STAFF RECOMMENDATION
2700 Oakland Avenue
June 19, 2019

Application: New Construction—Addition and Outbuilding
District: Belmont-Hillsboro Neighborhood Conservation Zoning Overlay
Council District: 18
Base Zoning: R8
Map and Parcel Number: 11704016700
Applicant: Manuel Zeitlin
Project Lead: Paul Hoffman, paul.hoffman@nashville.gov

Description of Project: This application is for a rear addition to this contributing building.

1 Elevation - Street Side
1/8" = 1'-0"

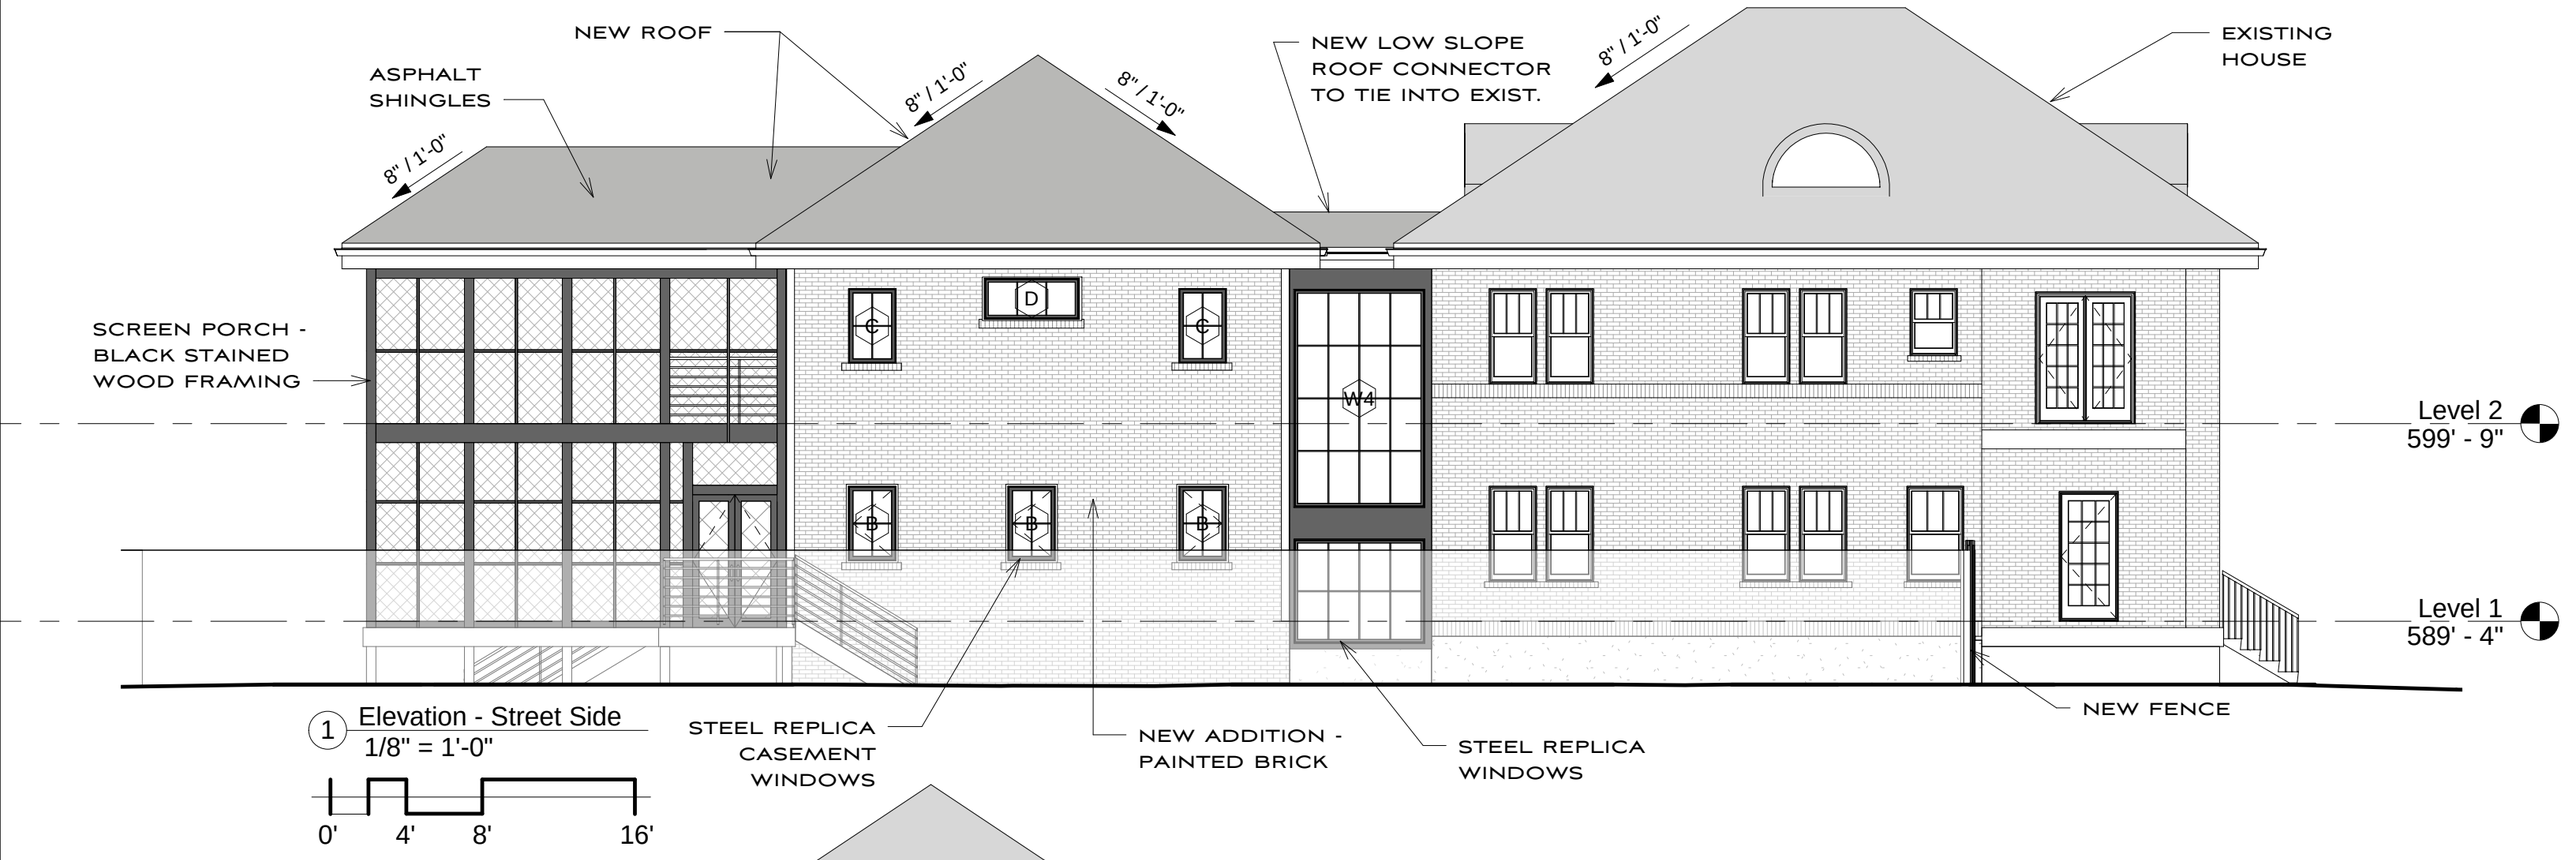
1. The horizontal window on the street side of the addition is revised to a traditional window proportion;
2. The foundation line is differentiated with a soldier course;
3. The driveway configuration to the rear yard is retained;
4. Staff approve the final details, dimensions and materials of windows, doors, garage door prior to purchase and installation; and,
5. Staff approve the walkways, driveways, roof color and masonry color, dimensions and texture.

Proportion and Rhythm of Openings**:** The submitted plans indicate no changes to the window and door openings on the existing house. The windows on the proposed addition are generally twice as tall as they are wide, meeting the historic proportions of openings. There are no large expanses of wall space without a window or door opening. There is one horizontal window proposed on the left side of the addition. The Commission has discouraged horizontal windows, especially on a street-visible façade. Staff therefore recommends that the horizontal window on this side be revised to an historic proportion of windows. With this condition, staff finds the project's proportion and rhythm of openings to meet Section II.B.1.g.

1. The horizontal window on the street side of the addition is revised to a traditional window proportion;
2. The foundation line is differentiated with a soldier course;
3. The driveway configuration to the rear yard is retained;
4. Staff approve the final details, dimensions and materials of windows, doors and garage door prior to purchase and installation; and,
5. Staff approve the walkways, driveways, roof color and masonry color, dimensions and texture.
